APPLICATION FOR PERMISSION
UNDER SECTION 16 OF
THE TOWN PLANNING ORDINANCE
(CAP. 131)

元朗米埔丈量約份第 104 約地段第 3278 號餘段
臨時汽車維修工場連附屬辦公室及儲物用途 (為期 3 年)

Project 項目名稱:
Proposed Temporary Vehicle Repair Workshop with Ancillary Office and Storage Use for a Period of 3 Years at Lot 3278 RP in D.D. 104, Mai Po, Yuen Long

From: [REDACTED]
Sent: 2026年03月05日星期四 9:31
To: tpbpd/PLAND
Cc: Jessie Sin Yee LAU/PLAND
Subject: s16 No. A/YL-MP/405 : 補充文件
Attachments: Approved Drainage Proposal.pdf; Approved FS Plan.pdf
Categories: Internet Email

EXISTING 475 mm U-CHANNEL

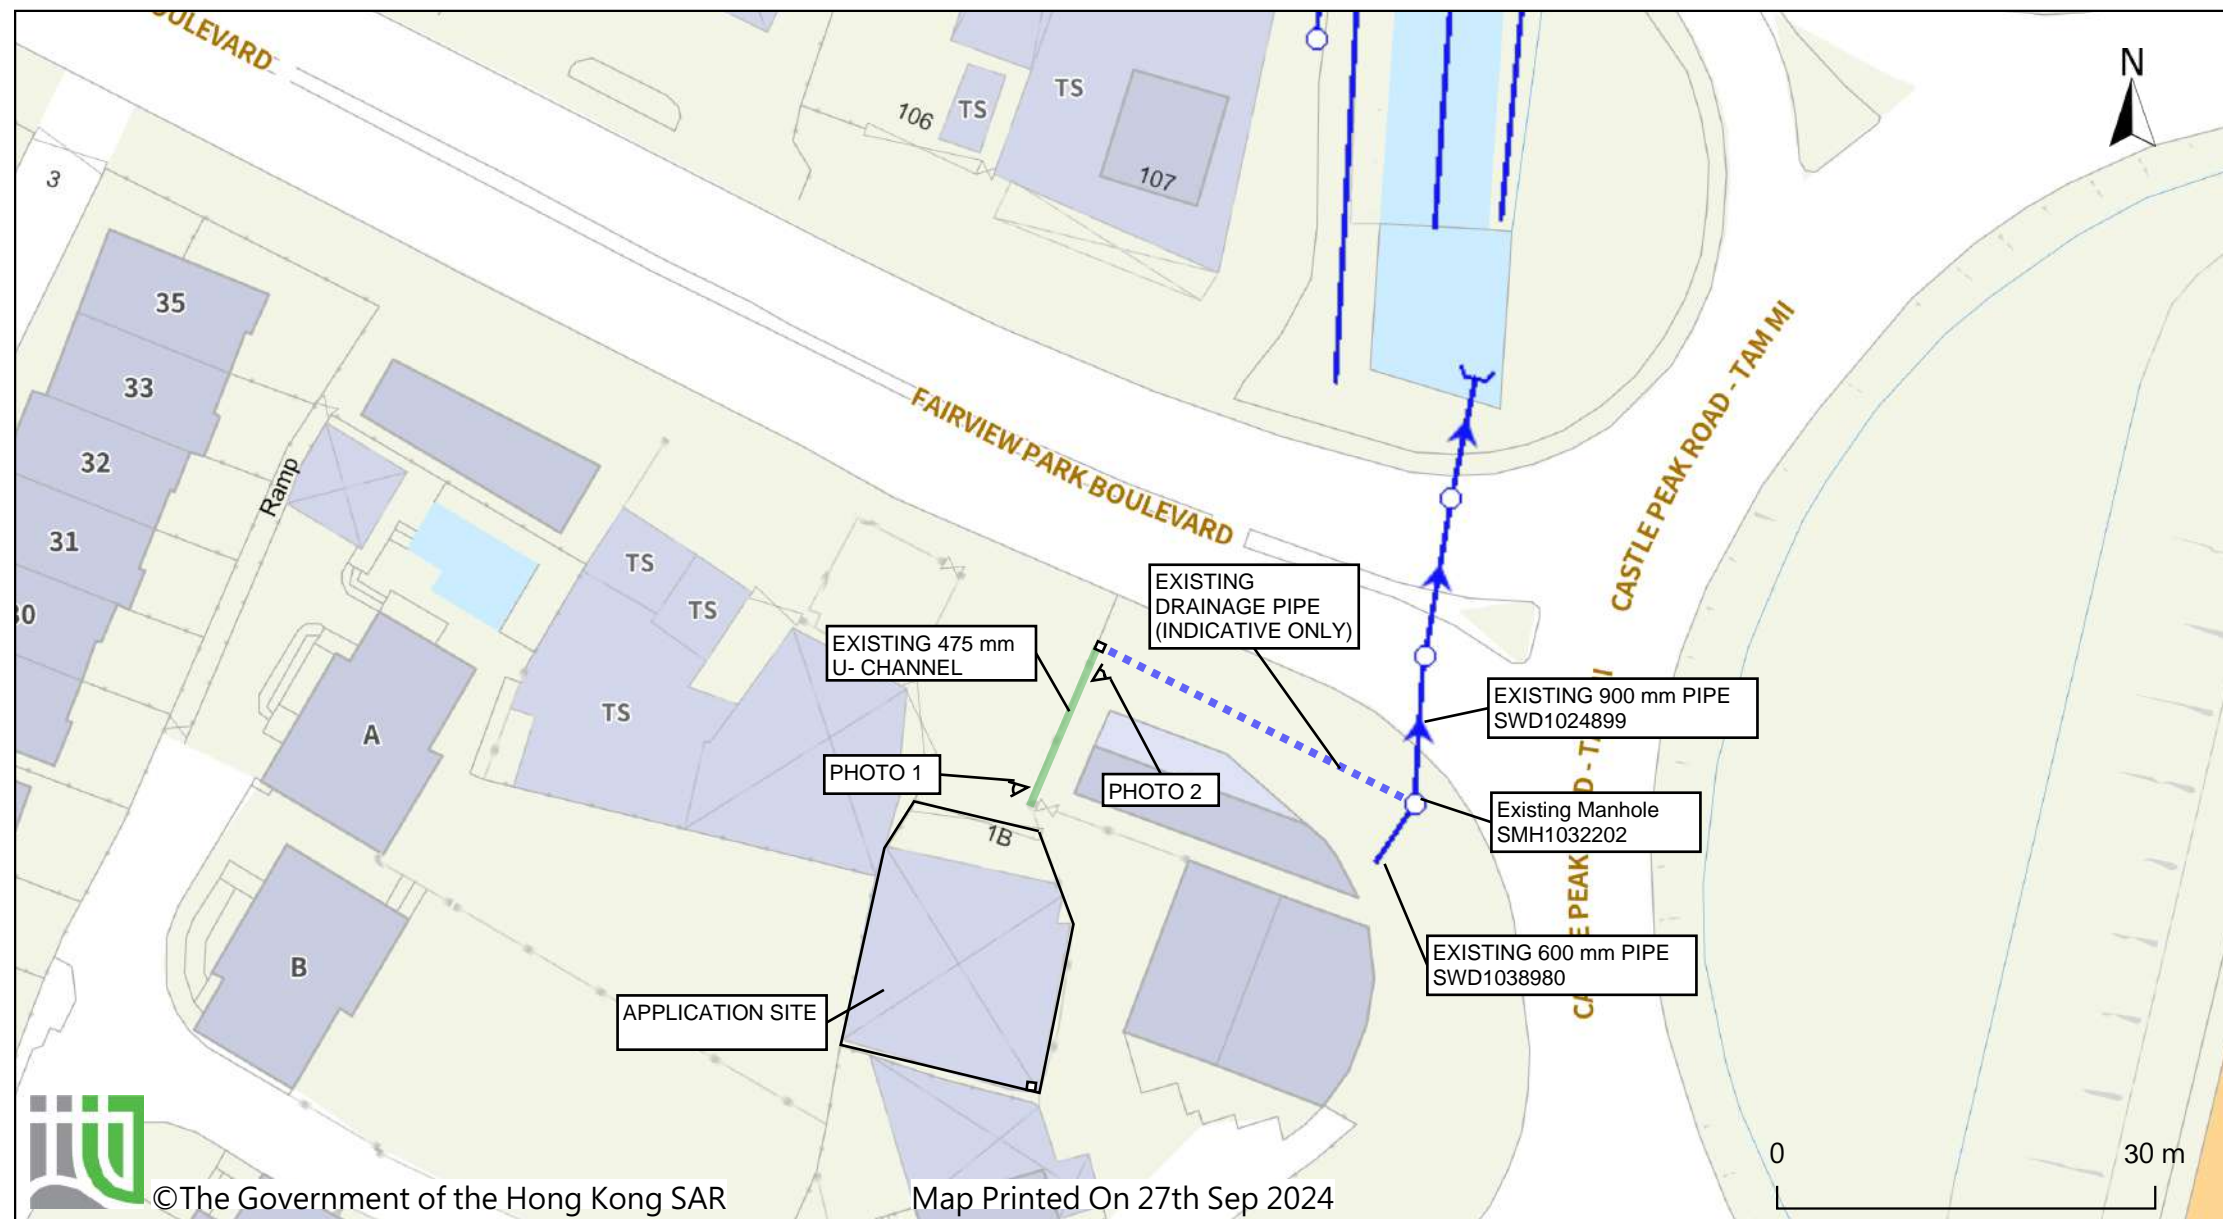
| | Comments | Response |
|-----|---|--|
| 6. | Please provide evidence to show the dimension of existing 475UC. | Please refer to updated Appendix C. |

DRAWING TITLE:
PROPOSED DRAINAGE WORKS

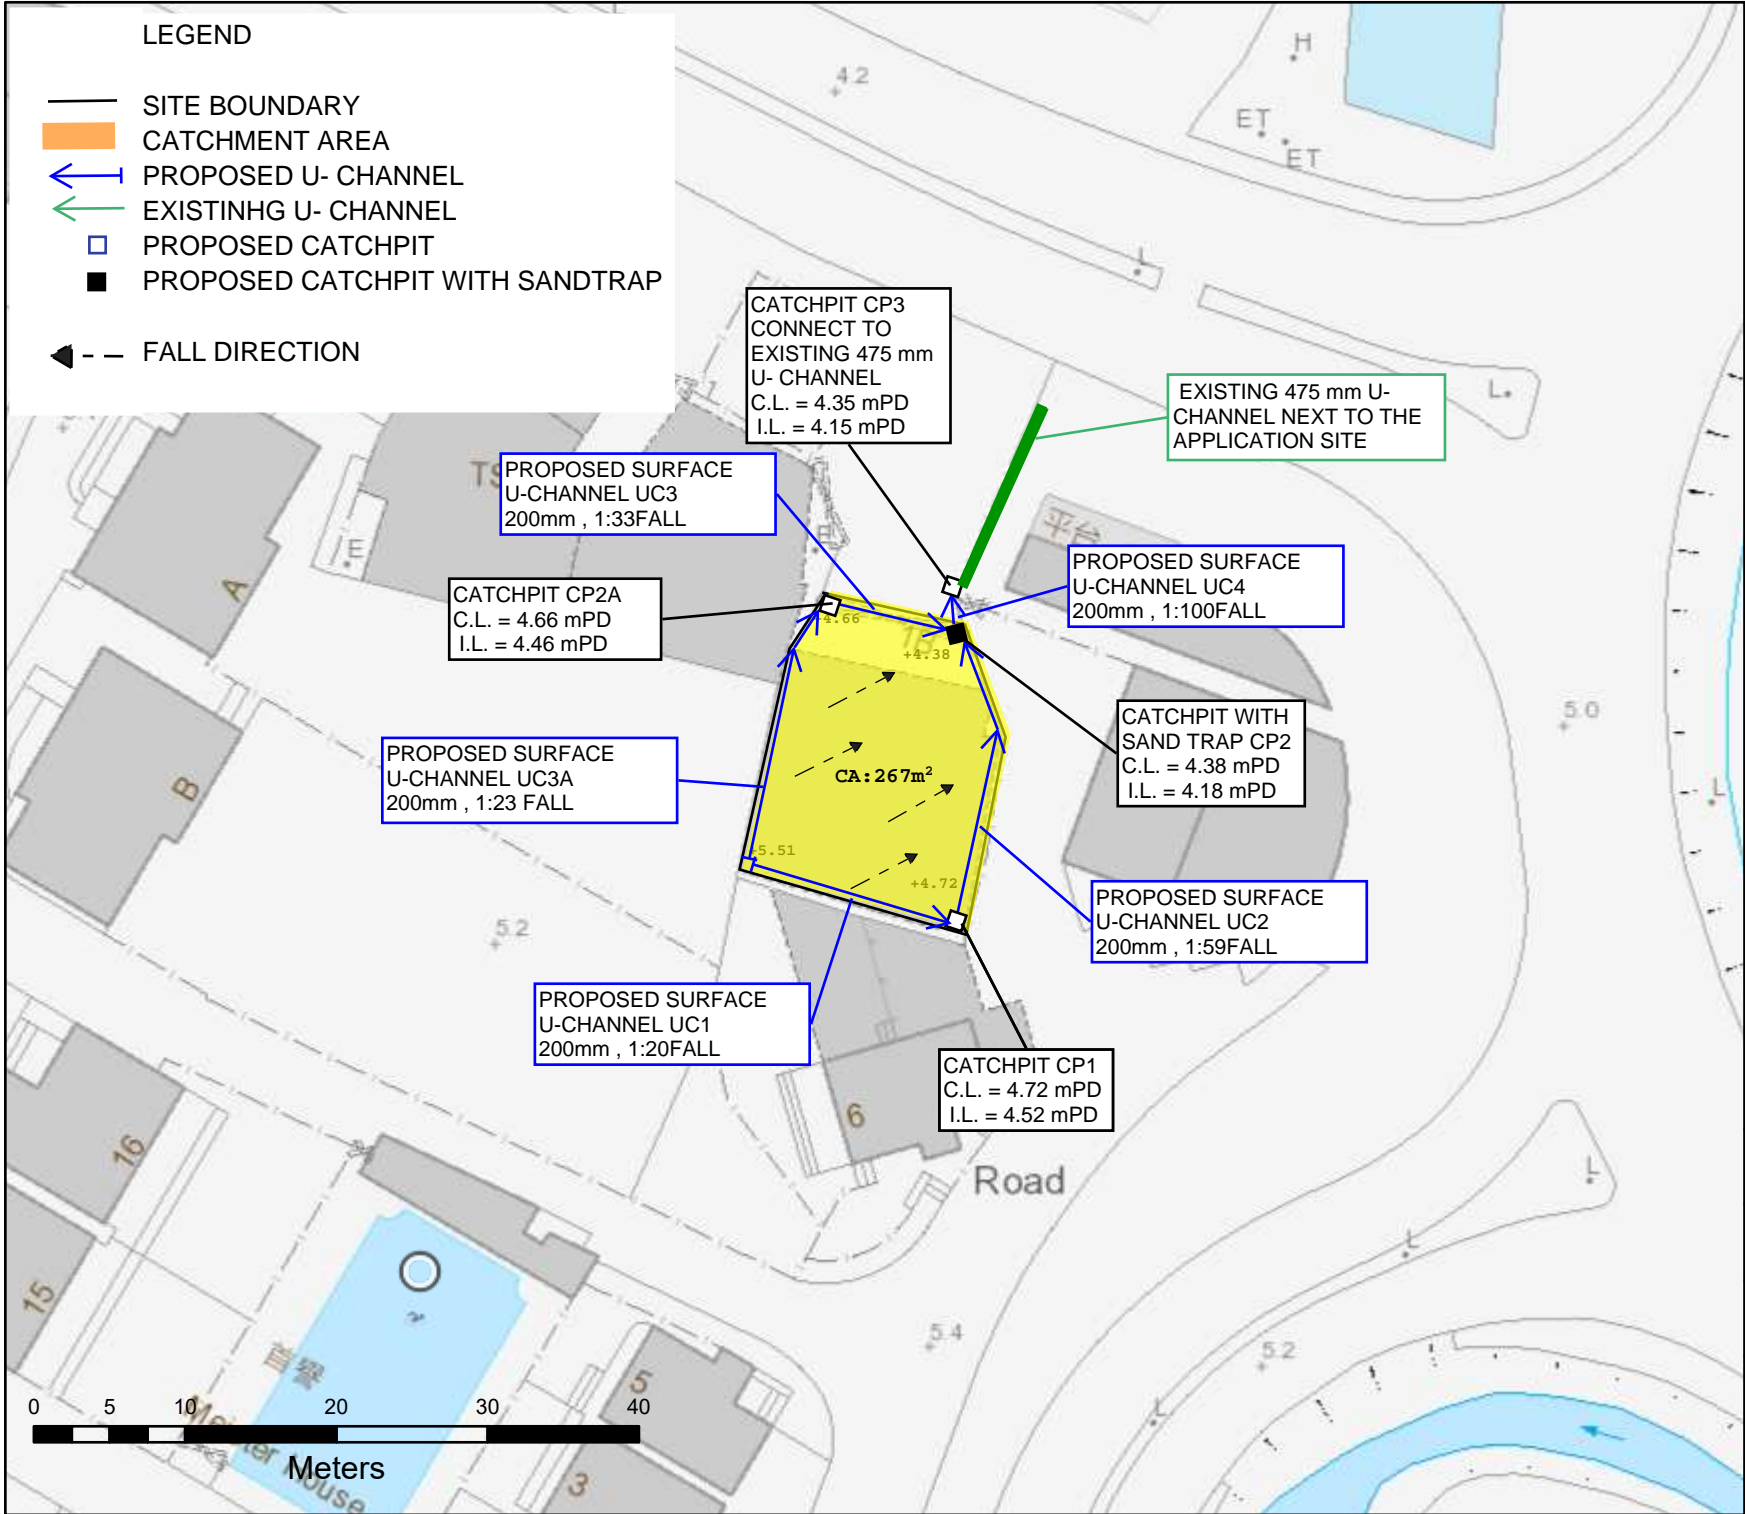
| | Comments | Response |
|-----|---|--|
| 3. | Peripheral drains should be provided for the application site to collect surface runoff. | Noted and surface channel UC3A is added. Please refer to updated Appendix D. |
| 7. | The cover and invert levels of the proposed u-channels and catchpits should be shown on the drainage plan. | Noted and appendix D is updated. |
